**STAFF REPORT
KETCHUM PLANNING AND ZONING COMMISSION
SPECIAL MEETING OF MARCH 30, 2021**

PROJECT: Deep Powder Townhomes

APPLICATIONS: Mountain Overlay Design Review (File No. P21-018) & Townhouse Subdivision Preliminary Plat (File No. P21-017)

STAFF REPORT
KETCHUM PLANNING AND ZONING COMMISSION
SPECIAL MEETING MARCH 23, 2021

SITE PLAN

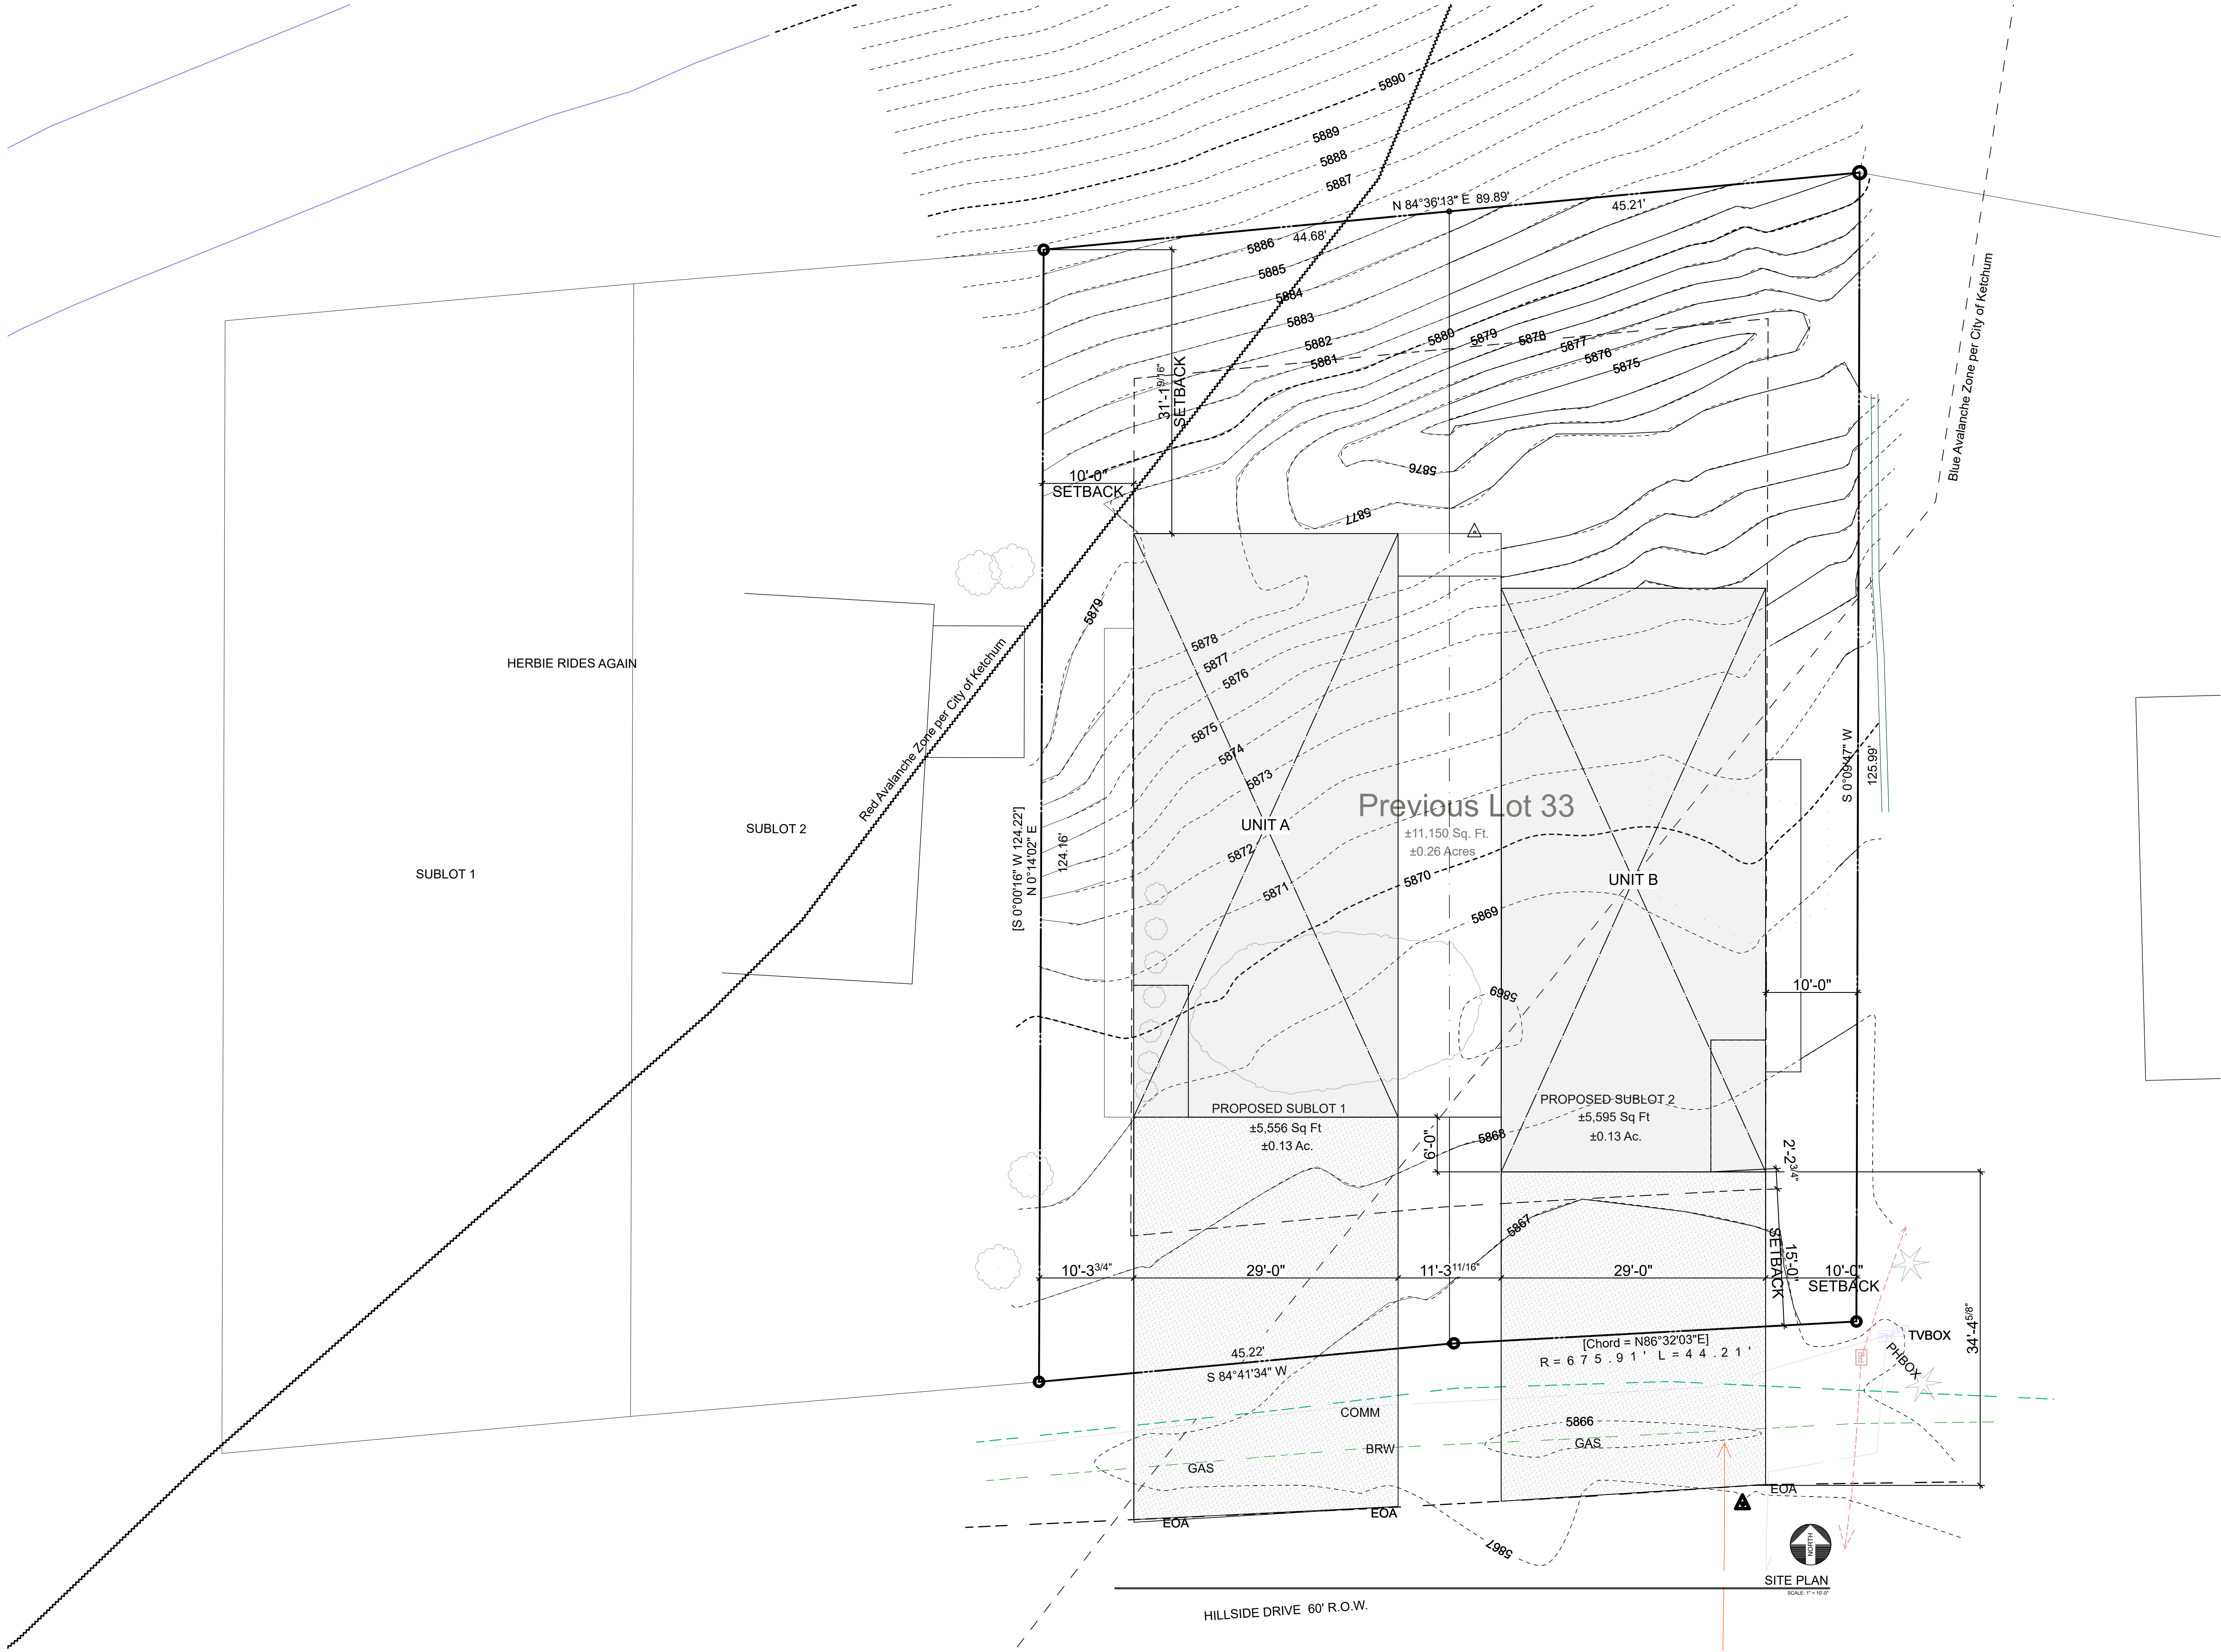
1. As they depict on their Site Plan, page A.1.0, their west building sits 10' from our common property line and extends approximately 8' north of our building and 16' south of our building. It is a very long structure.
2. On sheet A.3.0, their building elevations show the 64' length of their west elevation sitting just 10' from our common property line. Their plans contemplate continuing their roof south covering a 14' deck over the garage. This unnecessary imposing roof structure will severely impact and take away light and air from our indoor and outdoor living areas.

NORTH ELEVATION UNIT A
SCALE: 1/4" = 1'-0"

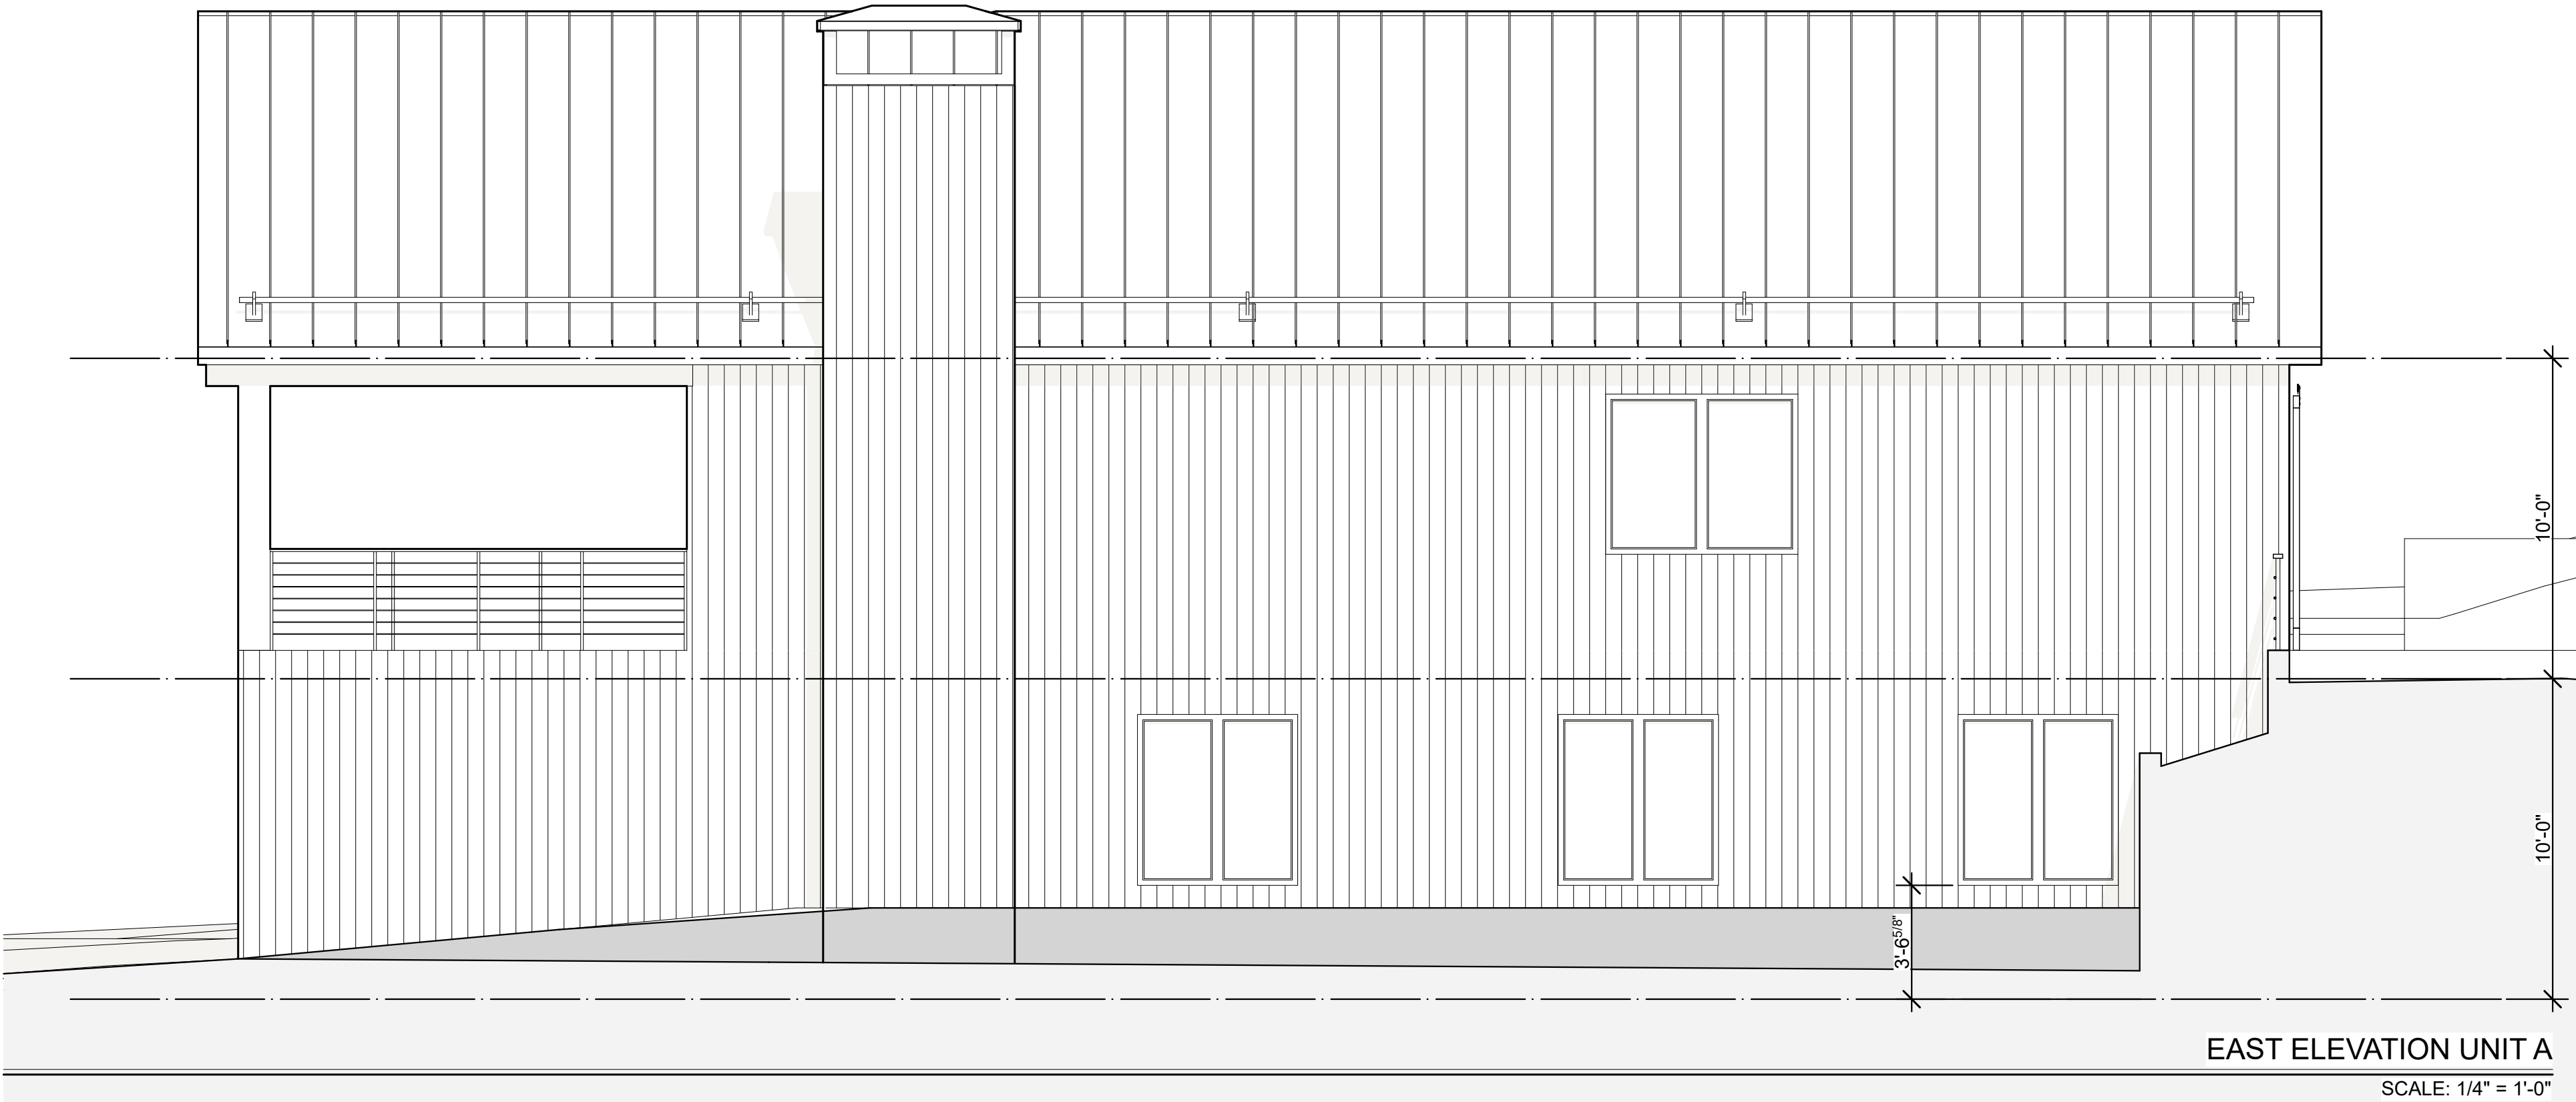
1. All departmental conditions as described in Tables 1, 2, 3, 4, and 5;
2. Limits of disturbance/construction fencing indicated on Sheet L2.0 shall remain in place for the duration of construction;
3. The elevation plans indicate a partial avalanche protection wall on the west side of the western building (Unit A). The design is to be determined. The applicant is aware that the wall cannot exceed 6' in height and that the wall cannot encroach more than 3' into the setback that has been established by the building's height. If final design results in a wall that is greater than 3' wide the western building's footprint will be shifted east (toward Unit B) in order to meet the side yard setback requirement.
